DEVELOPMENT REVIEW COMMITTEE (DRC) COMMENT REPORT

PROJECT NAME: Mod Lab

CASE NUMBER: R18015

REQUEST: Site Plan Level II Review: 111 Multifamily Residential Units and 7,300 Square Feet of Commercial Use in the Northwest Regional Activity Center

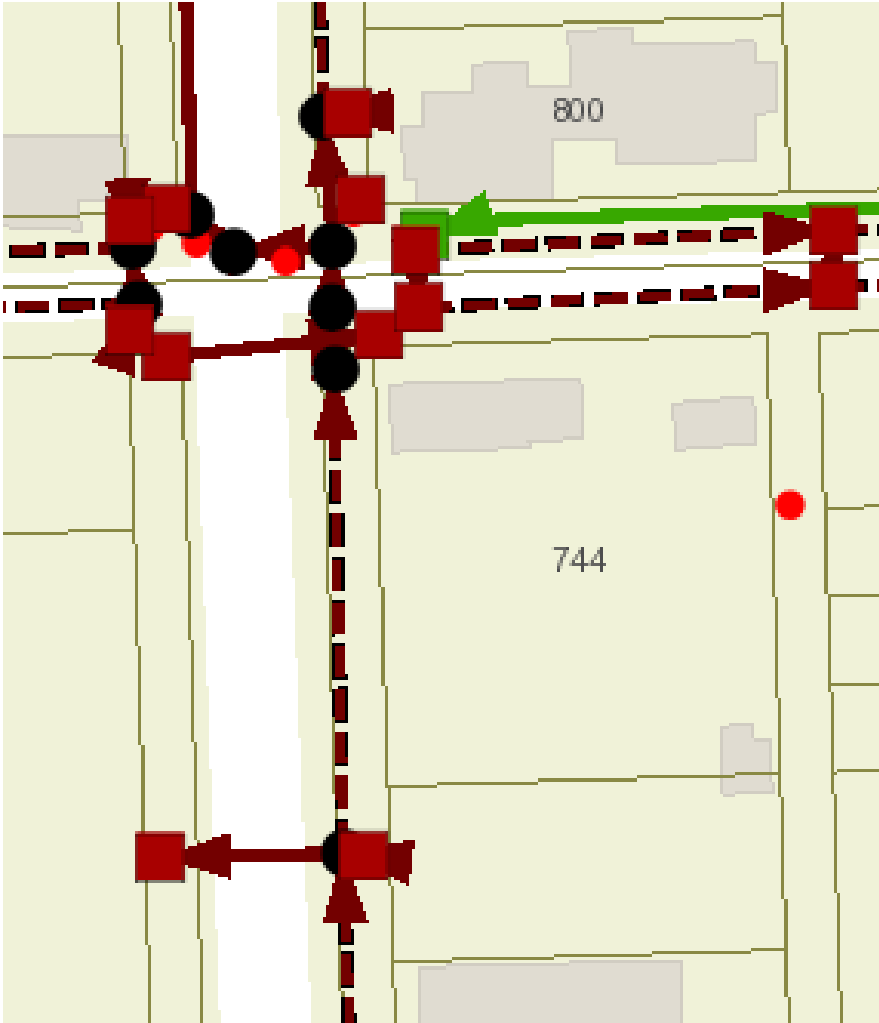
The City owns and maintains stormwater infrastructure adjacent to the proposed development as shown in the map provided at the end of this report. The following comments pertain to possible impacts of the proposed development and/or construction activities to the existing condition of the City's stormwater assets. The applicant shall provide an itemized response letter addressing the following comments:

1. Please provide (or revise if already submitted) an erosion, sedimentation, and stormwater pollution prevention plan (**SWPPP**) showing the adjacent City's existing stormwater system as shown in the survey and to the limits shown with green line work in the storm map provided at the end of this report. A copy of the approved SWPP shall be at the construction site from the date of demolition initiation to the date of final construction activities.

- a) Contractor shall provide CCTV videotapes to City STW OPS of the existing stormwater system to the limits shown with green line work in the storm map provided at the end of this report in order to document the PRE and POST construction conditions of the City's storm system.

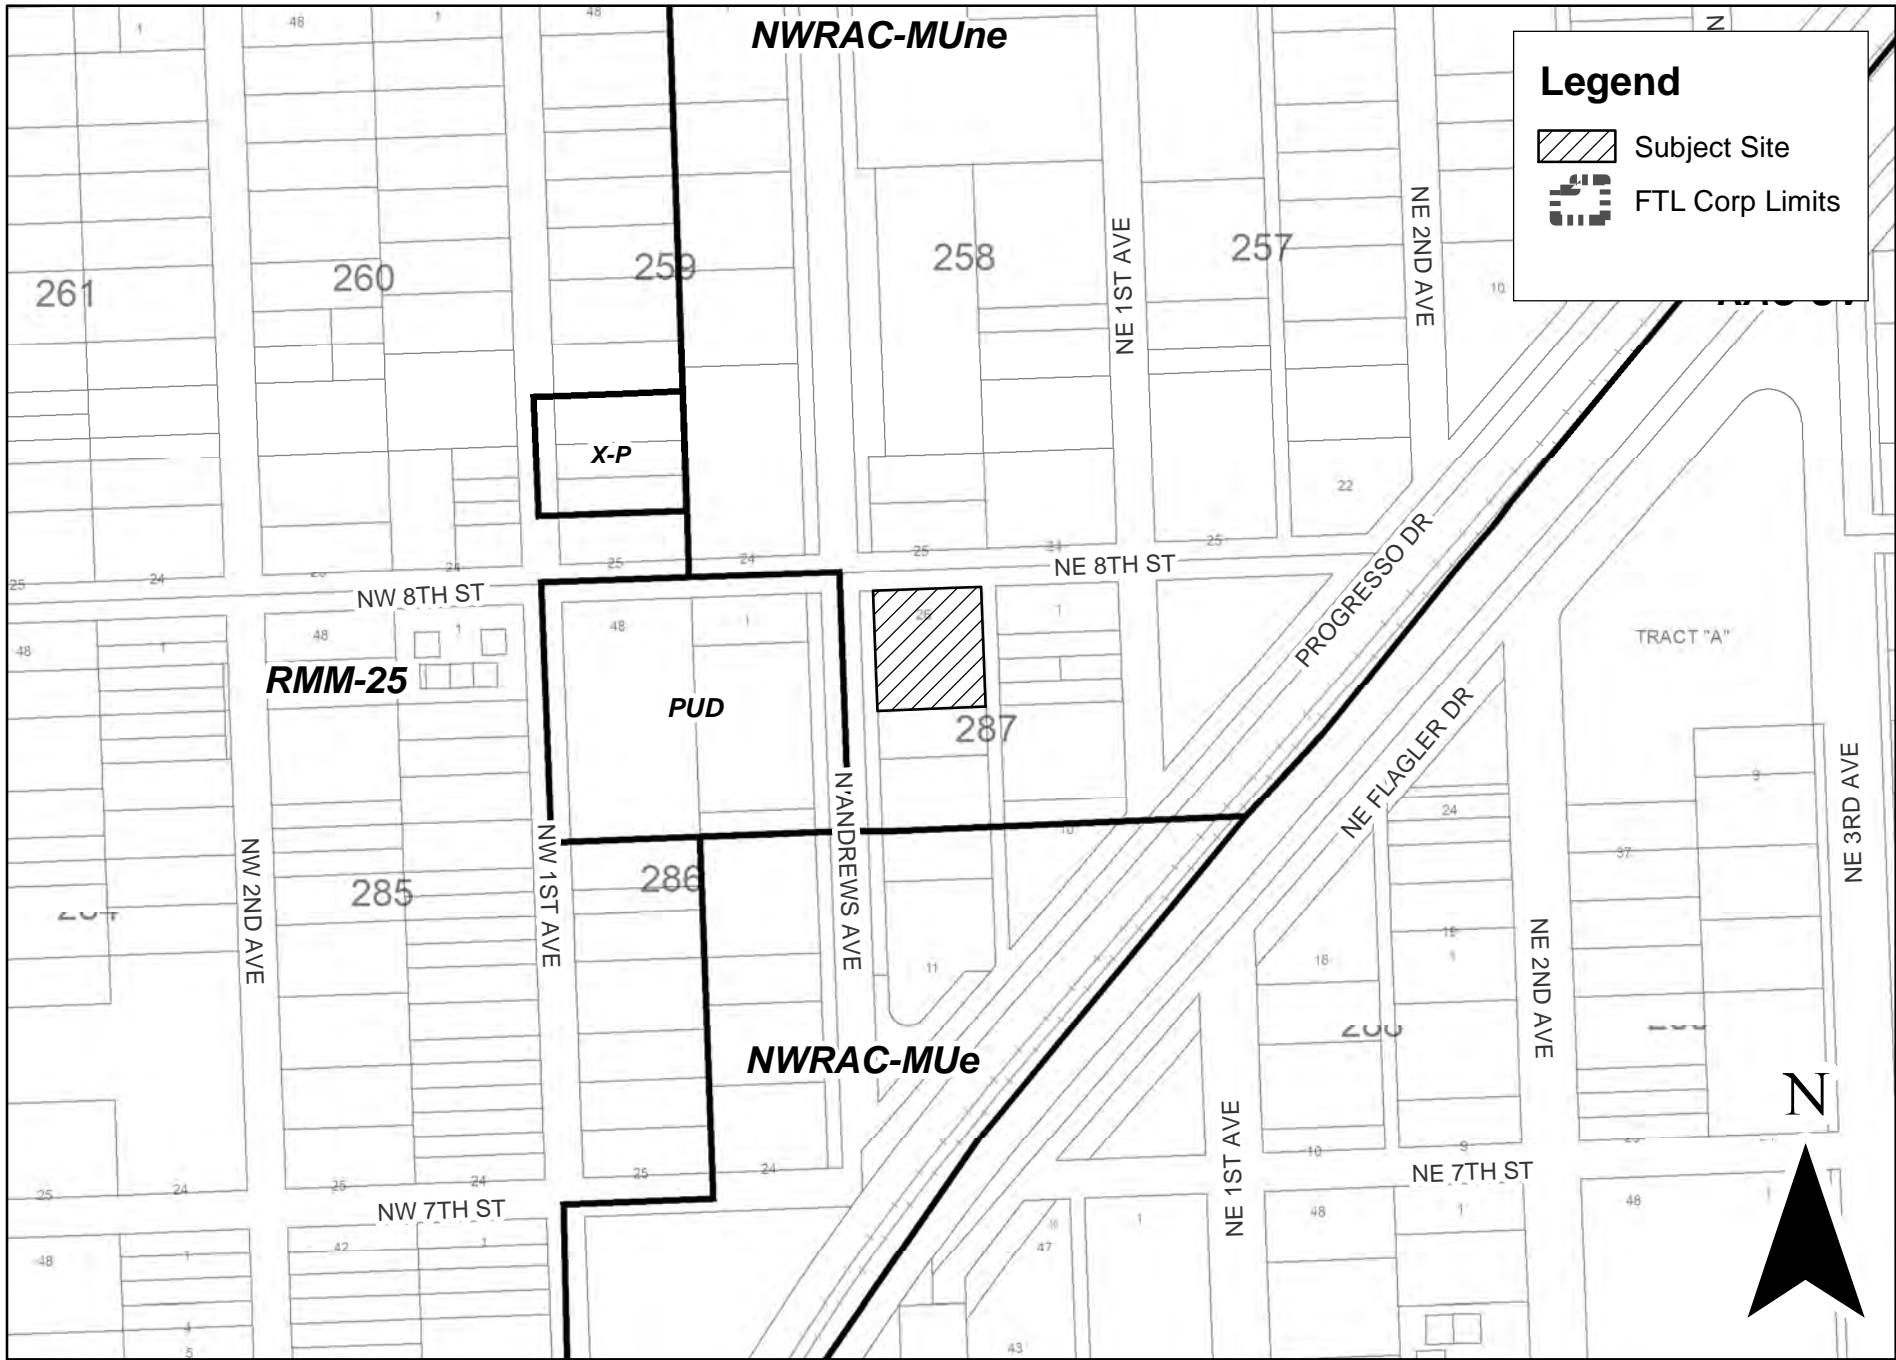
9. Provide the following changes to the site plan:

- a. Relocate proposed landscaping along NE 8th Street to provide unobstructed sidewalk and a buffer between sidewalk and traffic lanes. Coordinate location of landscaping with Landscaping, TAM and Public Works Departments representatives;

- b. Provide grouping of minimum 2 palm trees to mark intersections;
 - c. Explain the 3 feet dedication along the alley;
 - d. All mechanical parking shall be graphically indicated on the site plan and referenced within the tabular data. In addition, details and specifications for mechanical parking shall be provided. Note that all proposed mechanical parking is subject to a valet parking agreement pursuant to Sec. 47-20.18.

- e. Indicate all utilities (both above and below ground) that would affect the proposed planting or landscape plan. Overhead lines (if any) should be placed underground. If the lines cannot be placed underground, provide documentation from Florida Power & Light Company indicating such.
